SUBJECT: CONTAINER LIFE AND SOURCE TERM KEY TECHNICAL ISSUE AGREEMENT
CLST.2.03; STATUS: NEEDS ADDITIONAL INFORMATION

NRC Review of DOE Documents Pertaining to Key Technical Issue Agreements

Container Life and Source Term Agreement CLST.2.03

Figure 1. Failure Assessment Diagram (Anderson, 1995, Figure 9.12)

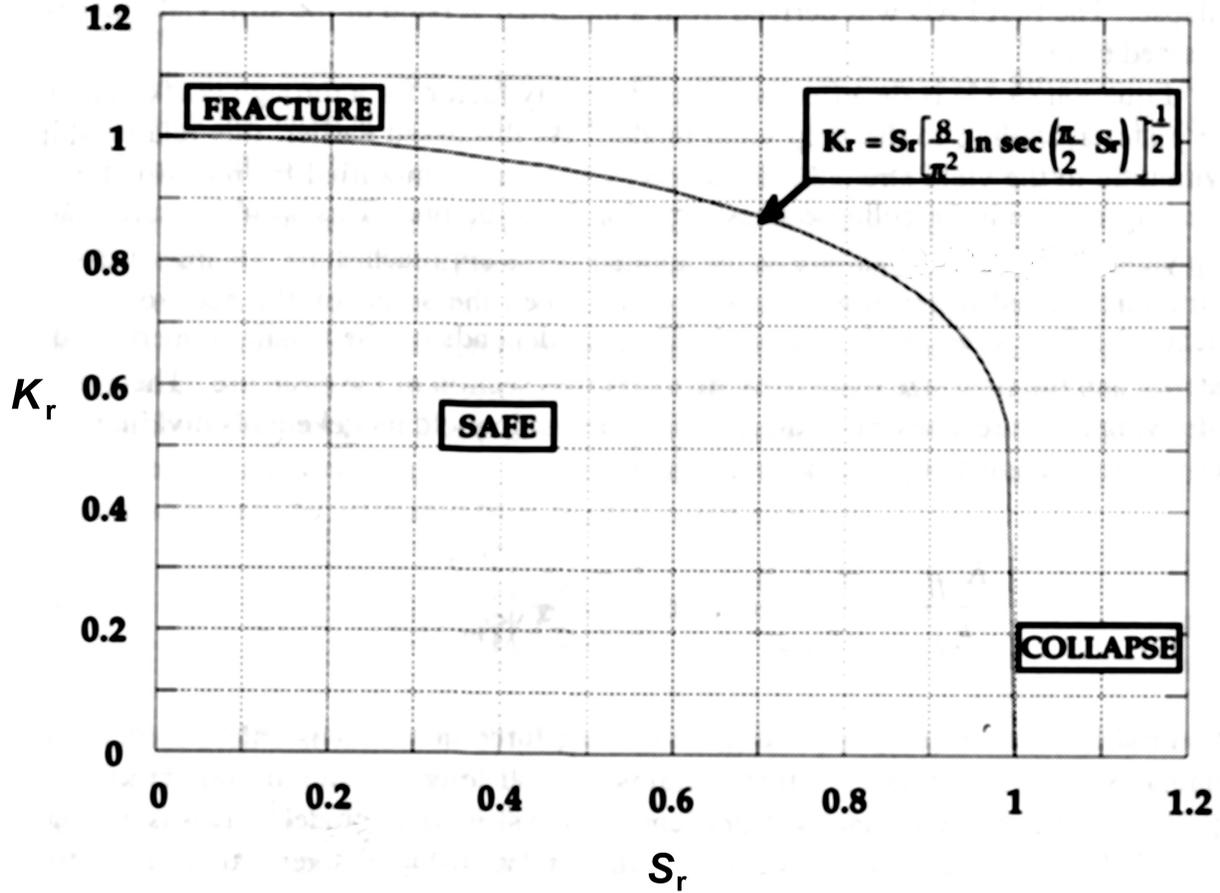
Referring to Figure 1, the structure will not fail from either fracture or plastic collapse if the locus of (S_r, K_r) is inside the safe failure assessment diagram failure envelope for a given applied

load. If the locus of (S_r, K_r) lies outside of the failure envelope, the structure will fail under the applied load. If $S_r > 1$ and $K_r < 0.6$, then structural failure is dominated by plastic collapse and the ASME Boiler and Pressure Vessel Code failure criterion is applicable. Conversely, if $S_r < 0.4$ and $K_r > 1$, then structural failure is dominated by brittle fracture. For mixed mode

If it can be shown that $K_r \leq 0.6$ while $S_r \approx 1$ (Figure 1), or $K_r/S_r \leq 0.6$, then it can be reasonably assumed that failure of the structure will be attributable to plastic collapse and not brittle fracture. For the values of K_{Ic} and σ_c used for Titanium Grade 7 and Alloy 22, DOE demonstrated that $K_r/S_r \leq 0.6$ for all of the geometry and loading conditions considered (i.e., compact tension, single-edge, notched-bend, and single-edge, notched-tension). Note that a $K_r/S_r = 0.6$ ratio corresponds to a line rotated 31 degrees about the origin of the failure assessment diagram in a counter-clockwise direction from the abscissa.²

Although the basic approach to establishing the applicability of the plastic collapse and brittle fracture mechanics failure criteria is acceptable to the NRC staff, the estimates for the fracture toughness and plastic collapse stress for Titanium Grade 7 and Alloy 22 have yet to be adequately justified. Specifically, the justification for using Eq. (3) to estimate the fracture toughness of Titanium Grade 7 and Alloy 22 was not provided. As pointed out by Anderson (1995, Section 7.9.1), empirical correlations between Charpy V-notch impact toughness and fracture toughness "...seem to work reasonably well in some cases, but are unreliable in general." Moreover, Eq. (3) was developed specifically for correlating CVN and K_{Ic} for the upper shelf region of the brittle-ductile transition for pressure vessel steels (Barsom and Rolfe, 1970) and its applicability to titanium and nickel alloys has not been established. With regard to calculating the plastic collapse loads for Titanium Grade 7 and Alloy 22, DOE adjusted the ultimate tensile strengths of these materials from their engineering stress values to their Cauchy stress (i.e., true stress) counterparts. It is not clear that this conversion is justified within the context of a failure assessment diagram analysis [i.e., Eq. (2)] and additional documentation should be provided to substantiate this conversion.
